SERVICE BULLETIN
REVISION TRANSMITTAL SHEET

TITLE : AIR CONDITIONING - TEMPERATURE CONTROL - IMPROVE BASIC CABIN ZONE

CONTROLLER 8HK BITE

SERVICE BULLETIN NO: A320-21-1055

Zone - Controller - Removal/Installation Figure 1

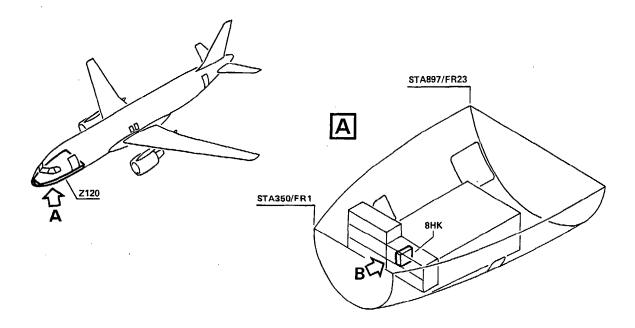
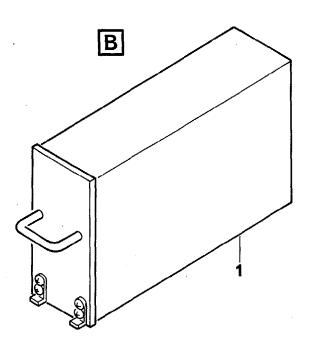
(1) Do the modification to the Zone-controller 8HK.

Refer to Figure 1.

(a) Remove the Zone-controller 8HK, item 1. (Ref. AMM 21-63-34, P. Block 401).

(b) Do the modification to the Zone-controller 8HK, item 1, as given in the LIEBHERR ABG-SEMCA Service Bulletin No. 775A-21-04.

(b) Do the modification to the Zone - controller 8HK, item 1, as given in the LIEBHERR ABG-SEMCA Service Bulletin No. 775B-21-01.

- (c) Change the part number of the Zone-controller 8HK, item 1, as given in Para. 3.C.
- (d) Install the modified Zone-controller 8HK, item 1, (Ref. AMM 21-63-34, P. Block 401).
